**TO:** All Bidders  
**FROM:** City of Cambridge  
**DATE:** December 10, 2013  
**RE:** File No. 5849C –Dr. Martin Luther King Jr. School Construction  
Project- Addendum NO. 2

**Addendum No. 2**

Regarding: Bid Addendum 2 – Administrative

DR. MARTIN LUTHER KING JR. SCHOOL CONSTRUCTION PROJECT  
CAMBRIDGE, MA  
FILE NO. 5849C

PROJECT NO. 47831.00  
SCALE: As indicated  
SHEET  
REFERENCE:  
DWG. NO.: **SKS-4**

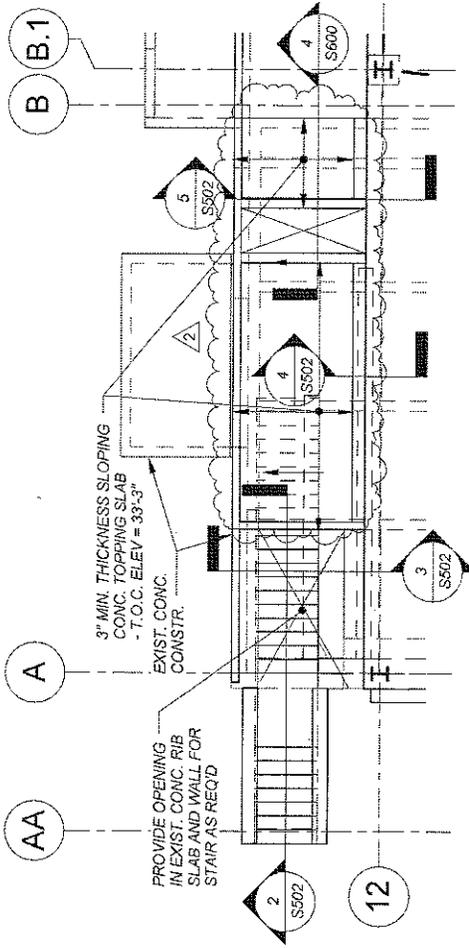
DRAWING TITLE: New Section 16 on S600 - Sump Pit Construction  
DATE: 12/10/2013 BID ADDENDUM 2

DWG. NO.: SKS-5

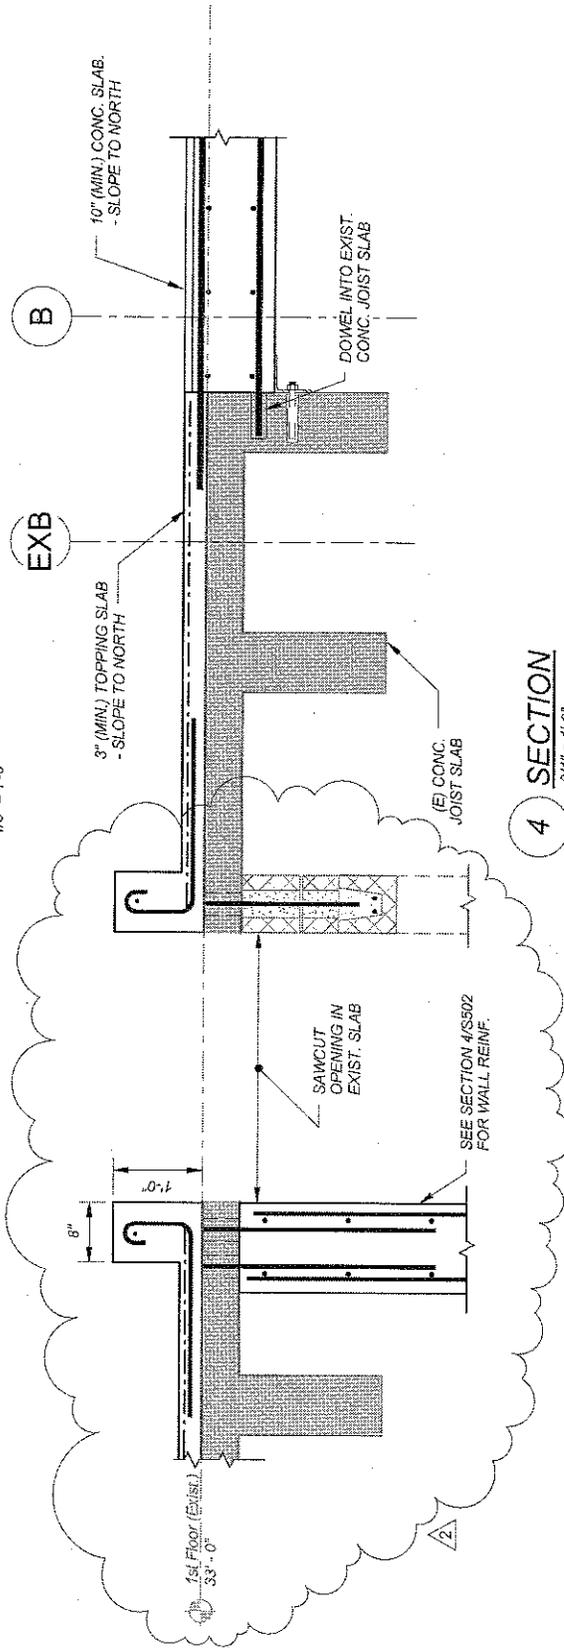
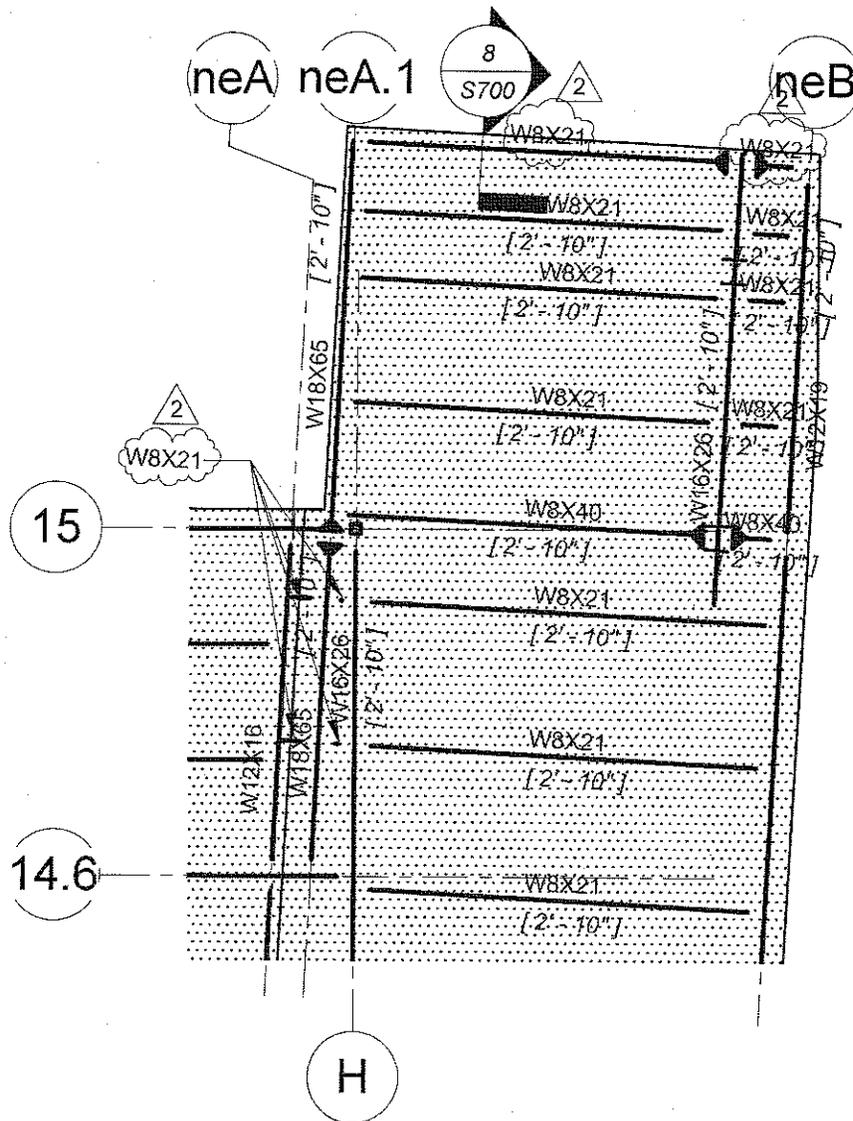
DRAWING TITLE: Clarification of Slab Extents and Revisions to Section 4 on S600  
DATE: 12/16/2013 BID ADDENDUM 2

DWG. NO.: **SKS-6**

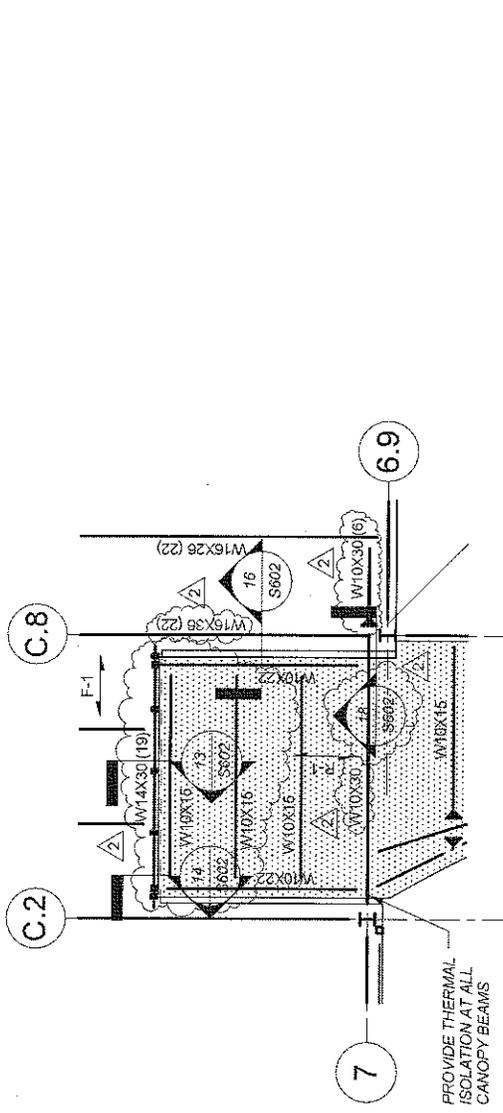
References:	S111.2, S111.3
		Description:	Revise the elevations of HSS12x8x1/2 beams along ne5, neE, ne1, se1, and seC from [-2'-10"] to [-2'-9"] (13 beams total).
59	Structural	Subject:	Beam Sizes
		References:	S111.2, SKS-6
		Description:	Add W8x21tags to six unidentified beams at North entry canopy as shown in SKS.
60	Structural	Subject:	Section Reference
		References:	S111.2
		Description:	Section 12 on S602 applies at HSS12x8x1/2 beams along ne5, neE, and ne1.
61	Structural	Subject:	Add Studs
		References:	S111.2
		Description:	Add (22) studs to W16x26 beams spanning from neB-L on 7.3.
62	Structural	Subject:	Move Beam
		References:	S111.2
		Description:	W10x22 from H.2-neB.1 along ne1 – offset to the South of ne1 by 12" and add note to provide connection between beam and Column neB-ne1. Connection between Column neB-ne1 and neB.1-ne1 also required.

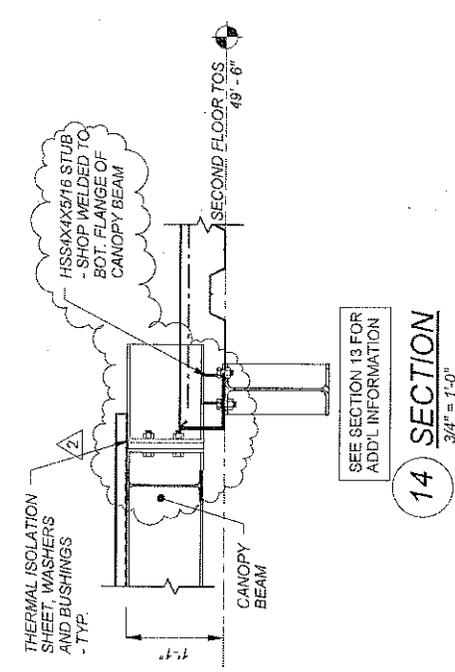
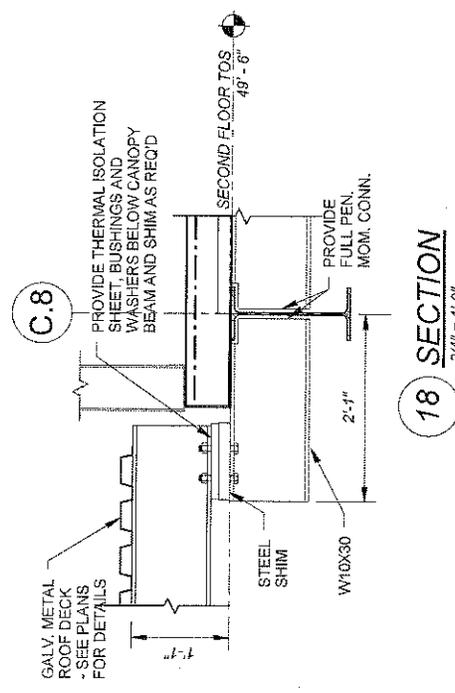
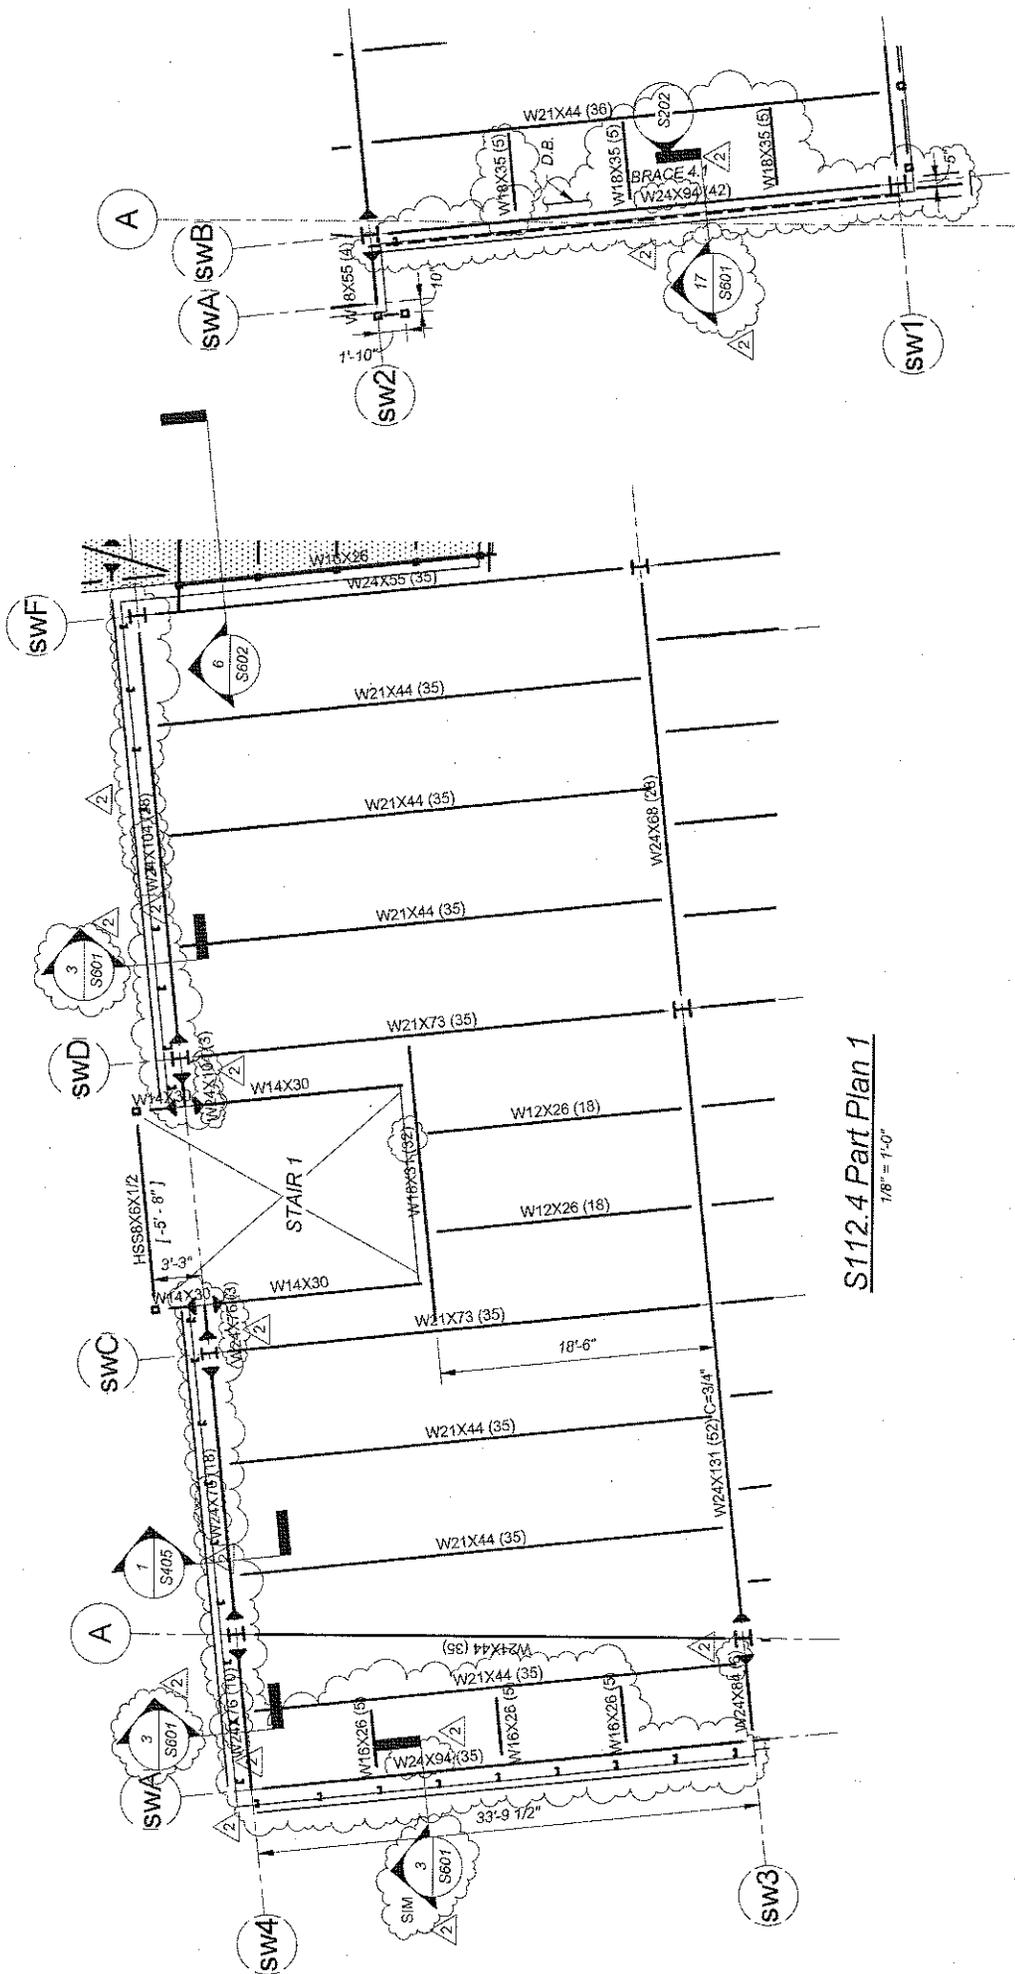
locations) to Section 3 (SIM) on S601.
78	Structural	Subject:	Revisions to Canopy
		References:	S112.1, SKS-7
		Description:	Add W10x30 on 7 at C.8 and revise framing per SKS. Change W16x26 beams spanning from C.2-C.8 on 7 to W10x30. Add Section reference mark for new Section 18 on S602. See SKS.
79	Structural	Subject:	Added Beam
		References:	S112.1
		Description:	W16x26 (22), from 6.9-8, 4 equal spaces between E and G.2.
80	Structural	Subject:	Revise Beam Spacing
		References:	S112.1
		Description:	Revise spacing of three W16x26 (22) beams spanning from 6.9-8, to make 4 equal spaces between G.2 and the beam on the West side of the MEP shaft.
81	Structural	Subject:	Number of Studs
		References:	S112.1
		Description:	Change number of studs on the following beams: W24x68 from C.8-E, on 8 – change studs from (27) to (30) W24x62 from E-G.2, on 10 – change studs from (26) to (30)
82	Structural	Subject:	Add Studs

PROJECT NO.: 47931.00  
 SCALE: 1/8" = 1'-0"  
 SHEET  
 REFERENCE:  
 DWG. NO.: **SKS-13**

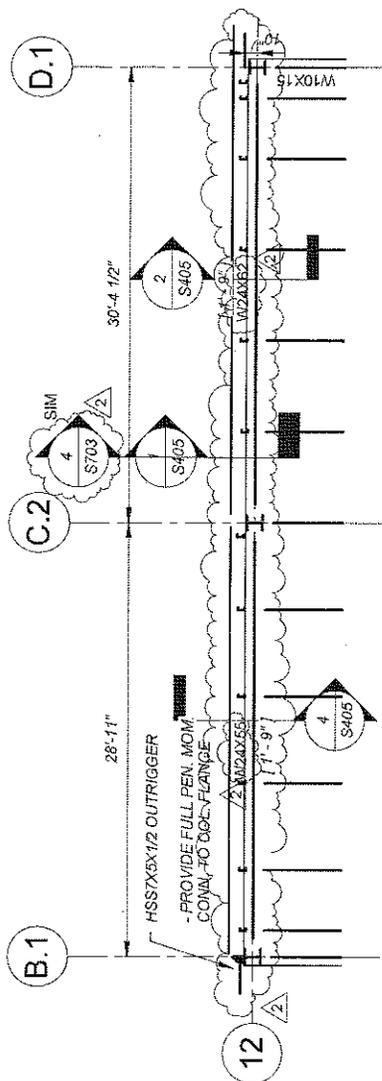
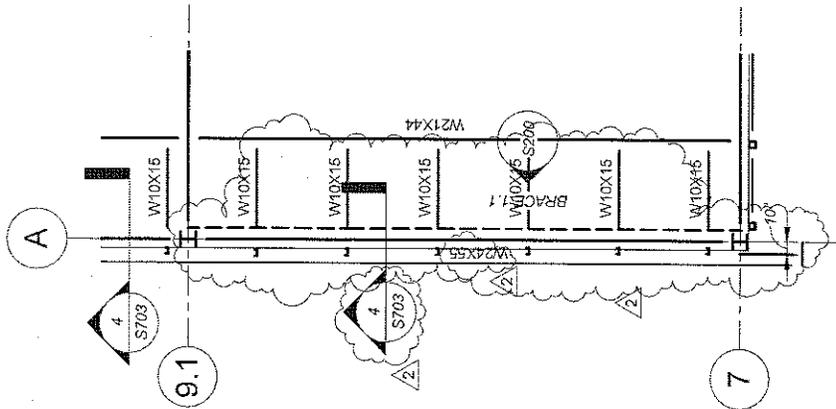
126	Structural	Subject:	Revised Concrete Slab Extents and Added Reinforcing
		References:	S114.1, SKS-13
		Description:	<p>Revise extents of concrete slab on roof deck and framing at roof top units as shown in SKS.                  Add reinforcing bars to slab.</p>
127	Structural	Subject:	Add Continuous Relieving Angle, Hangers and Bracing Beams
		References:	S114.1, SKS-14
		Description:	<p>Add continuous relieving angle and channel hangers along 12 and A as shown in SKS. Add six W10x15 bracing beams perpendicular to W24x55 on A. Add one W18x35 bracing beam perpendicular to W24x55 on 12. Add one W21x44 bracing beam perpendicular to W24x62 on 12.</p>
128	Structural	Subject:	Section References
		References:	S114.1
		Description:	<p>Change Section 2 on S703 reference mark along 12 to Section 4 (SIM) on S703.                  Change Section 1 on S703 reference mark along A to Section 4 on S703.</p>
129	Structural	Subject:	Revised Stair 3 Roof Framing

**DWG. NO.:** **SKS-14**

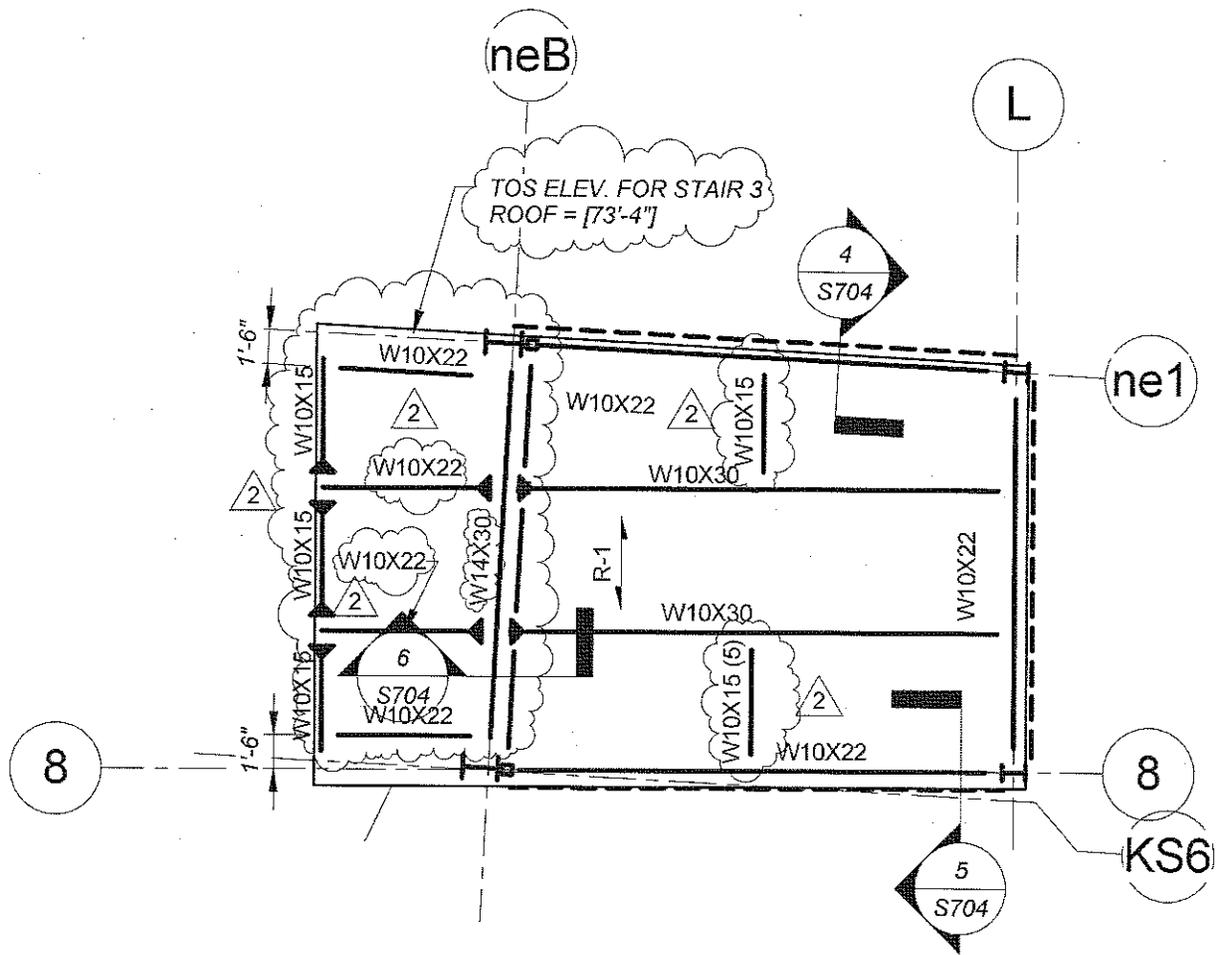
**DRAWING TITLE:** Added Relieving Angles at Upper School Roof  
**DATE:** 12/10/2013 BID ADDENDUM 2

<b>Perkins Eastman</b> 50 FRANKLIN STREET SUITE 203 BOSTON, MA 02110 T. 617.449.4000	PROJECT: <b>Dr. Martin Luther King, Jr. School</b>	PROJECT NO. 47931.00
	DRAWING TITLE: <b>Construction Project</b>	SCALE: 1/8" = 1'-0"
	DATE: 12/10/2013 BID ADDENDUM 2	SHEET REFERENCE:
		DWG. NO.: <b>SKS-15</b>

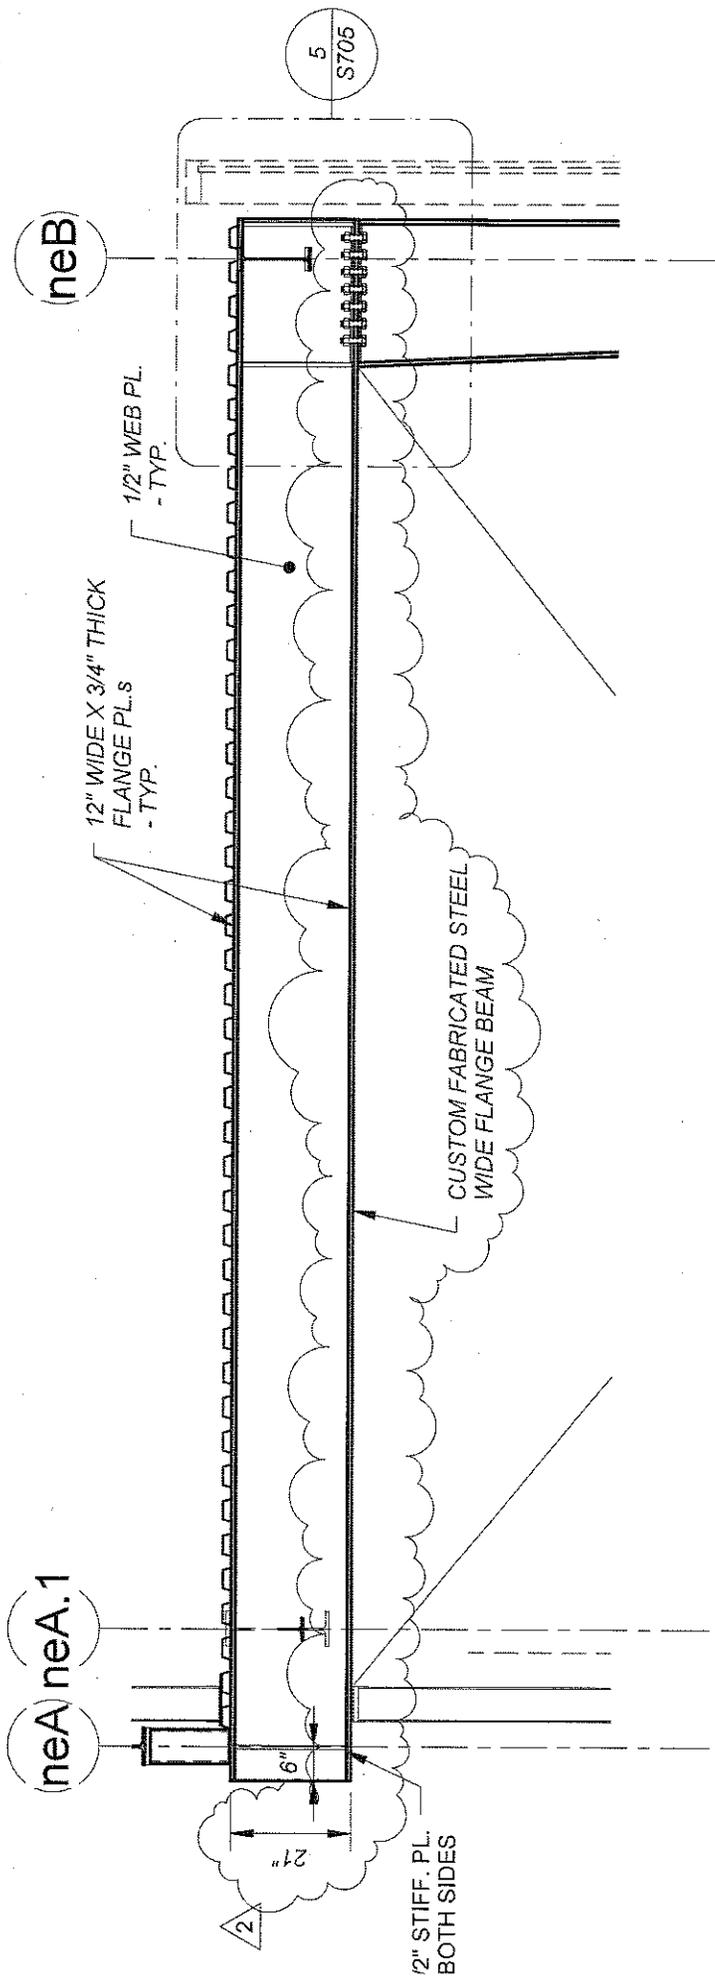
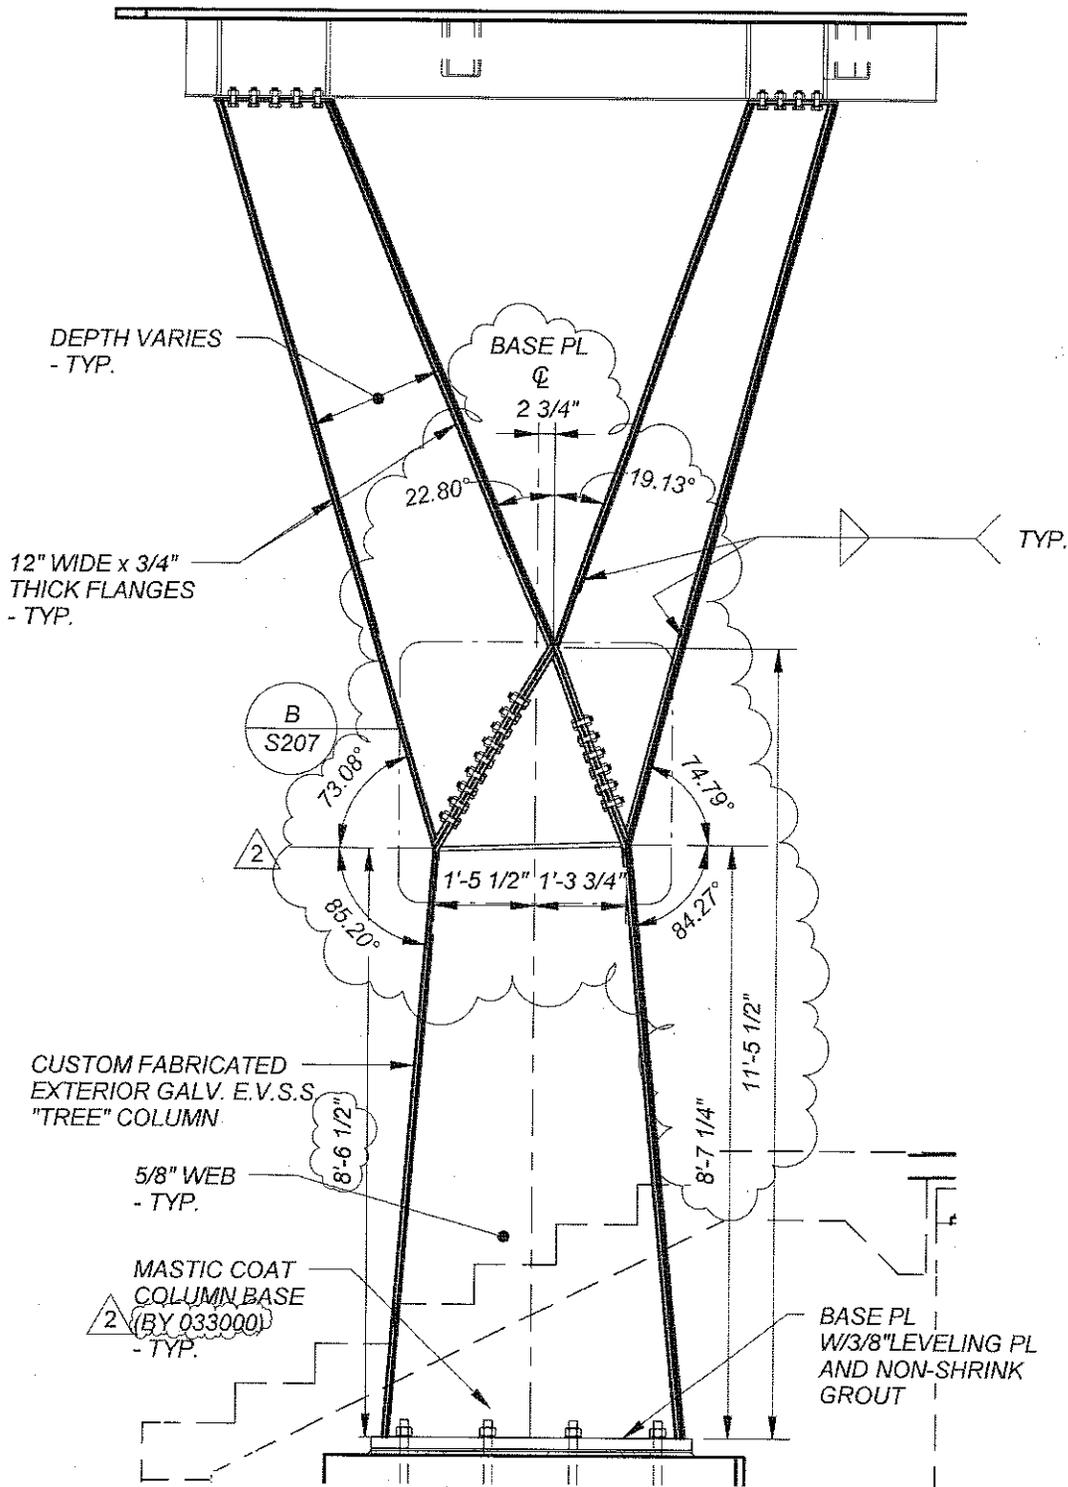
References:	S114.1, SKS-15
		Description:	Revise framing at Stair 3 Roof as shown in SKS.
130	Structural	Subject:	Beam Sizes
		References:	S114.2
		Description:	Change the following beam sizes:
